Westinghouse
Electric Corporation

DCP/NRC0991
NSD-NRC-97-5275
Docket No.: 52-003

SUBJECT: RESPONSES TO REQUESTS FOR ADDITIONAL INFORMATION ON CHAPTER
15.6.5 OF THE AP600 STANDARD SAFETY ANALYSIS REPORT (RAI 440.660 AND
RAI 440.662)

FIGURE 440.660-1

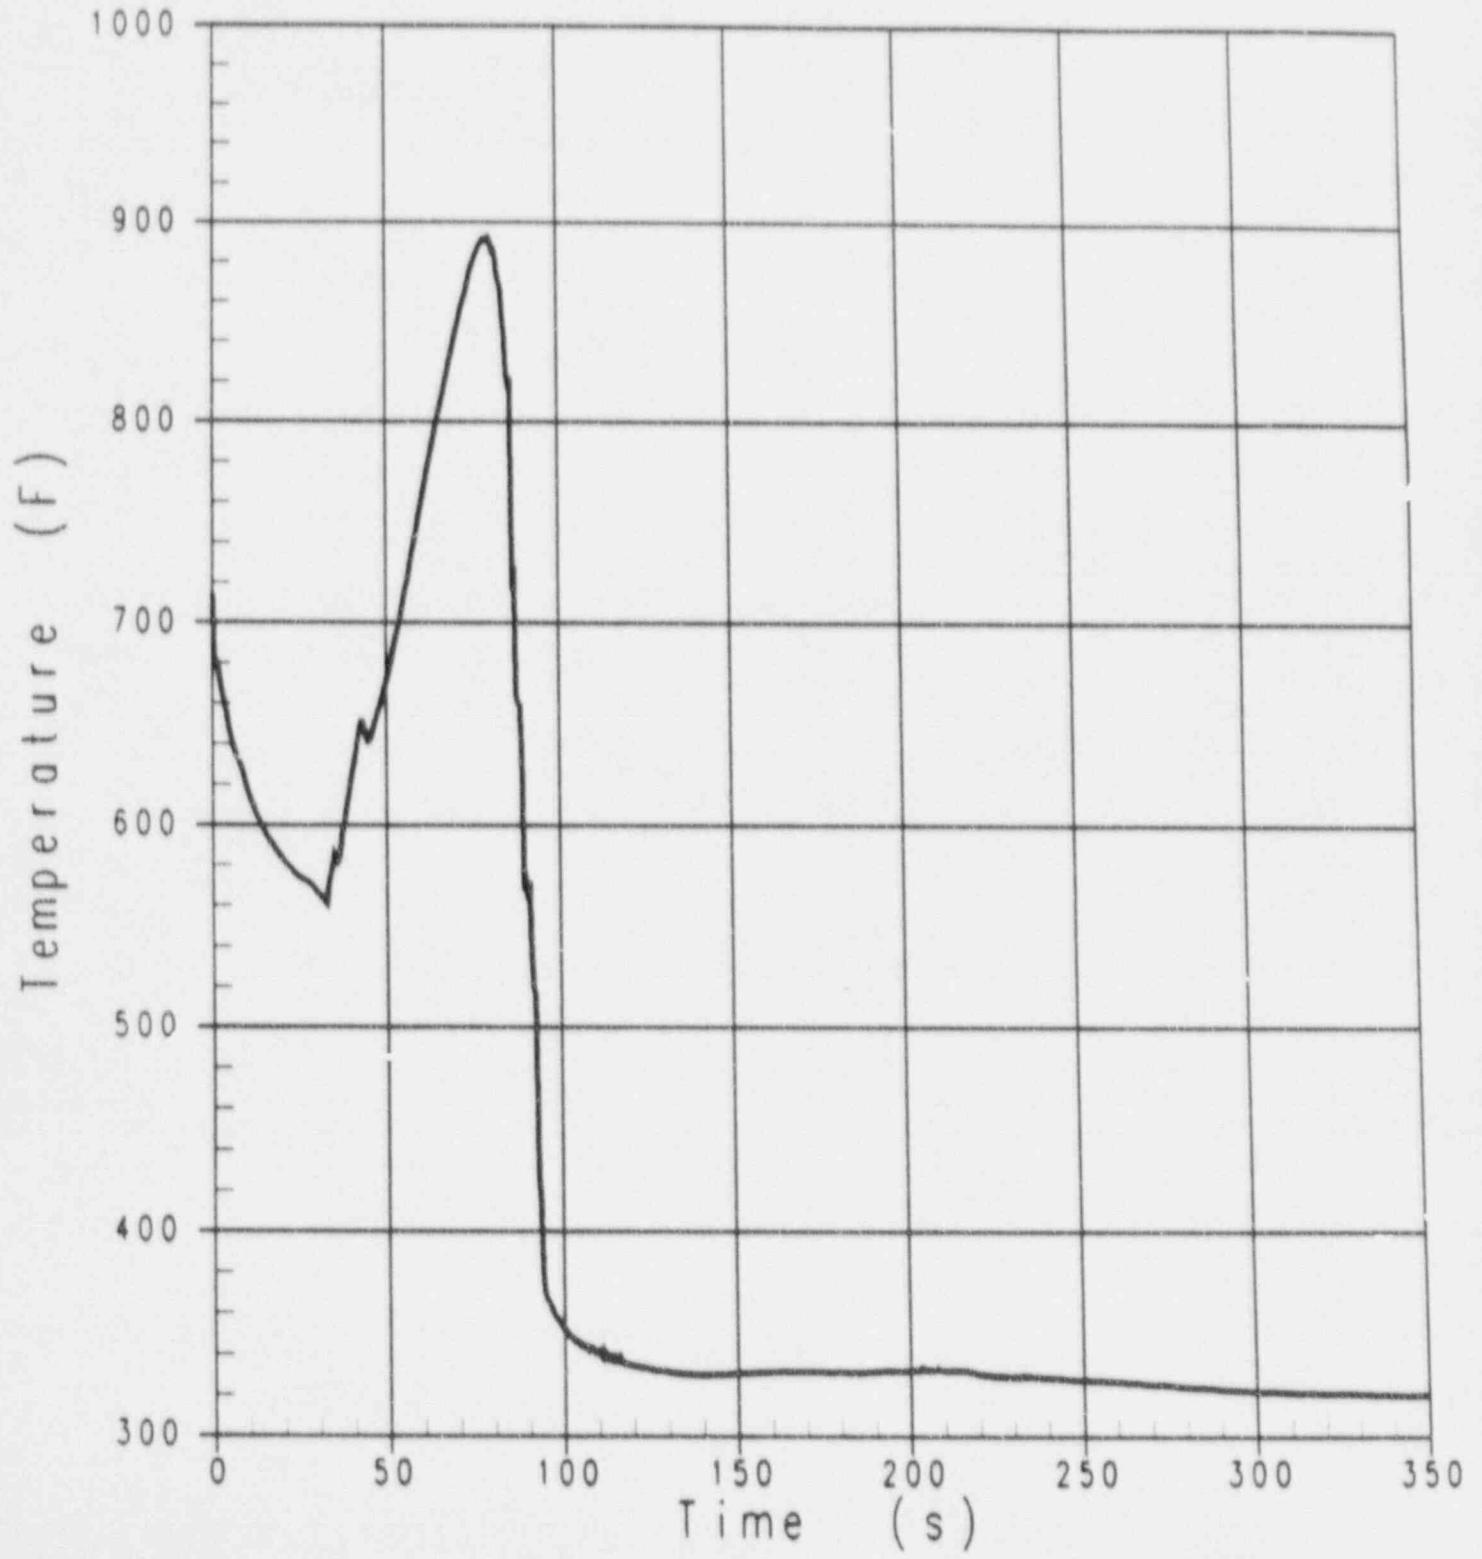
RAI 440.660:

SSAR 15.6.5 describes the results of the LOCA break spectrum study for AP600. The NOTRUMP code is used to perform small-break LOCA analyses for the range of breaks from 0.5-inch to 10-inch diameter (about 0.55 sq.ft. cross sectional area), while the WCOBRA/TRAC code is used to analyze large-break LOCAs for breaks ranging from a DECLG break to a break of 14-inch diameter (approximately 1.0 sq.ft. cross sectional area). Westinghouse should justify the use of the NOTRUMP and WCOBRA/TRAC for LOCA analyses in the ranges of break sizes as proposed in SSAR 15.6.5. In addition, the LOCAs with breaks from 0.55 sq.ft. to 1.0 sq.ft. cross sectional area should be analyzed and the results should be provided for the staff to review. The analysis should use methods acceptable to the staff and identify the limiting LOCA case to satisfy the requirements of item (a)(1)(i) of 10CFR50.46.

of SSAR Table 15.6.5-8; its hot rod PCT transient is shown in Figure 440.660-1, and PCT transients of the hot assembly, open hole, guide tube and peripheral assembly fuel rods are shown in Figure 440.660-2. The $CD=0.4$ split break is large enough to exhibit a downward (negative) liquid flow at the bottom of the core, but small enough that the liquid flow at the top of the core is positive (Figure 440.660-3). AP600 DECLG and large split break cases exhibit strong liquid downflow at the top of the core, as in SSAR Figure 15.6.5A-3, 6, 9, etc., during the latter part of the blowdown transient. The PCT excursion to the hot rod peak value of 892F occurs because the $CD=0.4$ split break is large enough to deplete the vessel core and downcomer of its liquid inventory before the accumulator provides adequate water flow to replenish the vessel. As shown in Figures 440.660-4, 5, and 6, the core hot assembly becomes void of liquid during the rod heatup, and the lower plenum and downcomer also are depleted of mass. Once the accumulators are available, the core hot assembly quickly recovers, as shown in Figure 440.660-7. The reduced break flow through the smaller size split break delayed CHF and subsequent rod heatup such that the blowdown heatup phase observed in the large break LOCA cases did not occur until the reactor vessel was refilling. The pressure in the upper plenum is shown in Figure 440.660-8. Later in the transient, once the accumulator delivery rate slows because the nitrogen gas pressure approaches the vessel pressure of 80 psia, the core makeup tanks inject the flow necessary to maintain the core and downcomer liquid levels. Eventually, the CMTs drain to the ADS actuation setpoint, and the ADS depressurizes the RCS to the containment pressure.

FIGURE 440.662-1

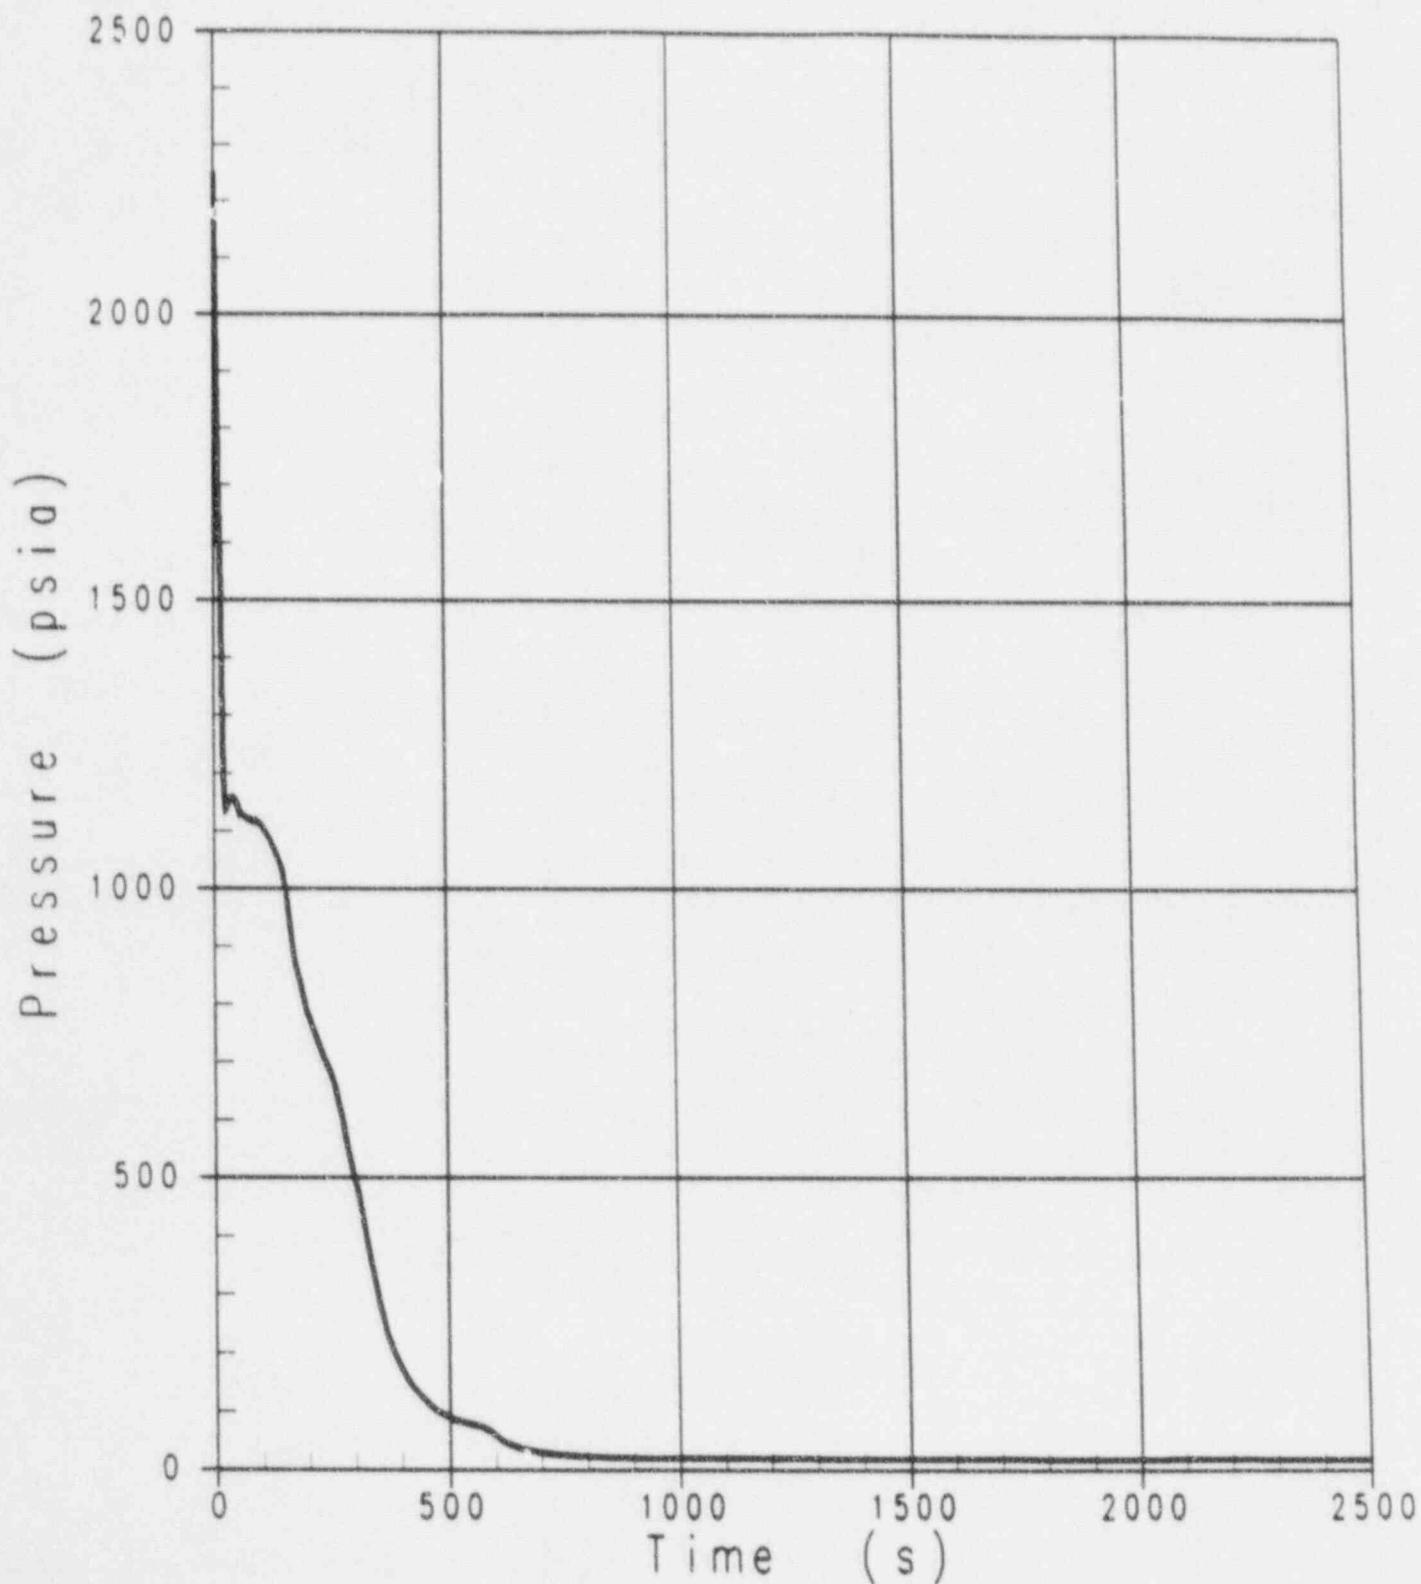
RAI 440.662:

SSAR Section 15.6.5.4B.1.0 states that the failure of one ADS-4 valve to open is the limiting single failure (SF) during small-break LOCAs. The qualitative argument presented in the same SSAR section does not clearly demonstrate why the failure of one ADS-4 valve to open is more limiting than the failure of one ADS-1 valve to open for the double-ended DVI (DEDVI) line break. Provide a quantitative analysis to confirm that the limiting SF is the failure of one ADS-4 valve during SBLOCAs.

The results of the double-ended DVI line break sensitivity case are presented in the attached sequence of events table and in Figures 440.662-1 through 11. Overall, the transient is changed little by the revised single failure assumption. Figures 440.662-1 through 11 may be compared with the corresponding figures from SSAR Figures 15.6.5B-12 through 29. Among items of particular note, downcomer pressure (Figure 440.662-1) decreases more slowly than in the SSAR DEDVI break until the ADS Stage 4 valves are activated, after which time the pressure quickly falls to approximately the SSAR case value. The core makeup tank and accumulator flows are little different from the SSAR values (Figures 440.662-2 and 3). With the entire ADS Stage 4 venting capability available, core and downcomer mixture levels in Figures 440.662-4 and 5 are sustained at higher levels than in the SSAR case, which shows variations in these levels. The top core node void fraction of Figure 440.662-6 is about the same as in the SSAR case.
